GWRC Review Comments

GWRC REVIEW OF Landscape Management Plan (LMP)

KCDC Review Comments

INDEPENDENT REVIEW OF LANDSCAPE MANAGEMENT PLAN

Attachment 10: Otaihanga Construction Yard

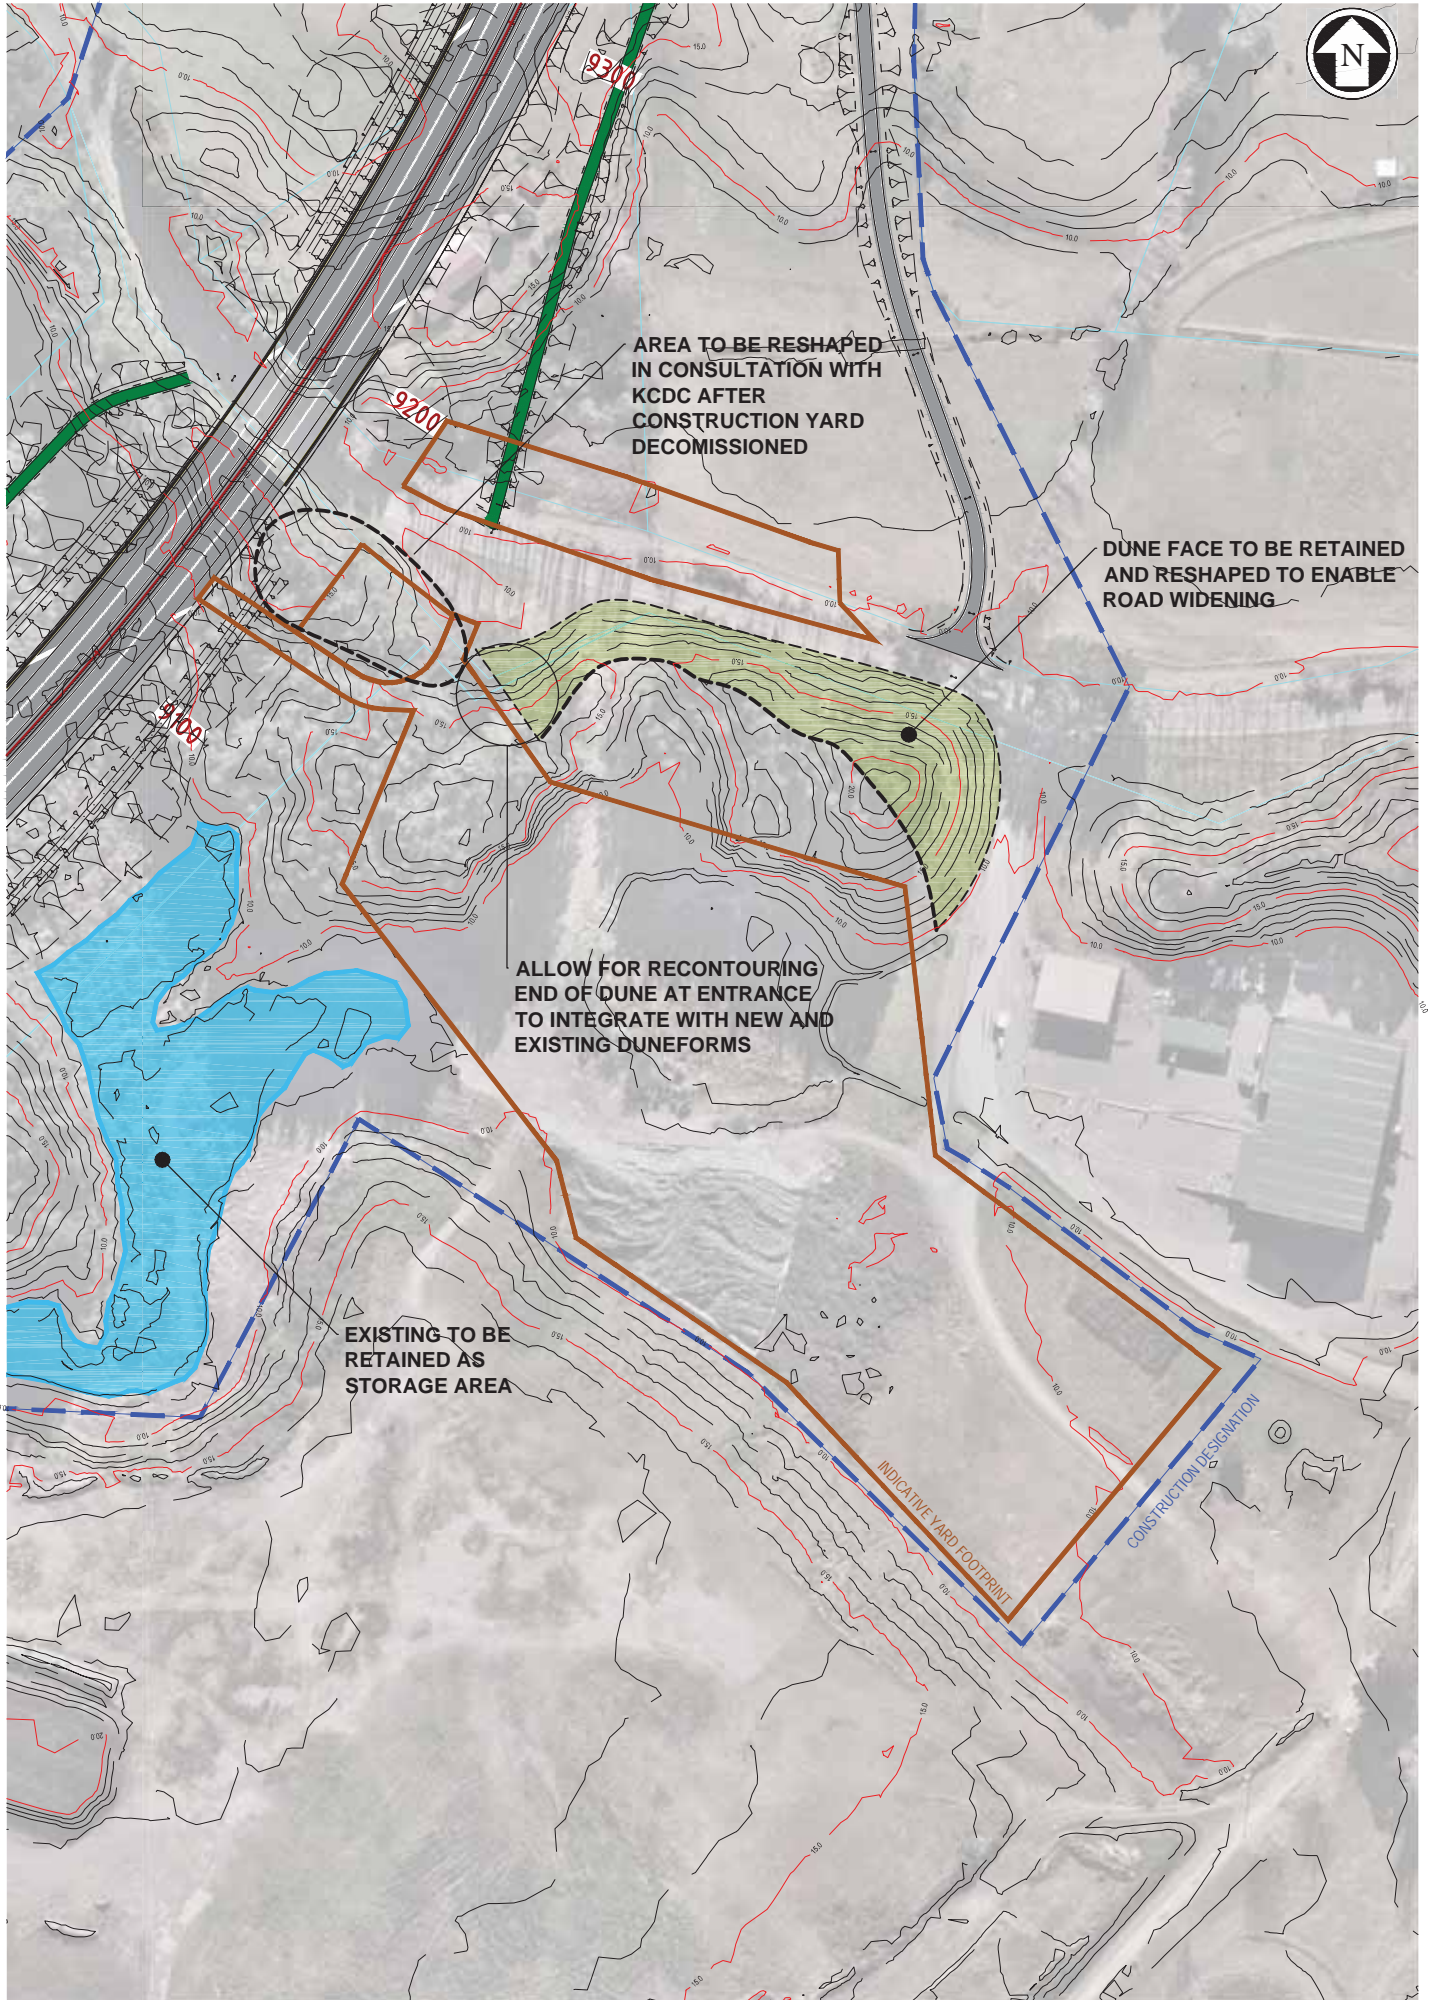
N/A	N/A	Directly moved from draft LMP. The only construction yard mentioned is in QE Park. No mention of other yards or the project yard at Otaihanga in terms of key landscape changes and mitigation.	Attachment 1 - Overall	sections added in Section 9 (9.7-9.19) Added Attachment 10 _Otaihanga Construction yard
N/A	N/A	Otaihanga South landscape character area Process/extent of mature pine plantation removal needs updating. Council expects this will have been resolved by the time the SSLMP for this landscape character area commences	Attachment 1 - Landscape mitigation by character area - Page 7	Changed wording ; ☑ Removal of some of the mature pine plantation . (extent of removal of pine plantation is yet to be determined and will be clarified during the preparation of the SSMP for this area) Currently unresolved expect to have clarity during process of SSLMP preparation
N/A	N/A	Earthworks: Methods Stockpiles graded to shallow falls to a maximum height of 2.0m. Default position for maximum height to be 1.0 m. Stockpiles may go to 2.0m high in locations where the topsoil has a high sand content.	Attachment 2 - Principles, methods and procedures -Page 12	Wording unchanged: the industry standard for stockpiling soil is specified. Due to space constraints within the designation and requirement by GWRC to avoid stockpiles in flood storage areas it will not be physically possible to store topsoil in 1m stockpiles where they are handy to the site. Storage beyond the designation would not be practicable and would require addition consents.
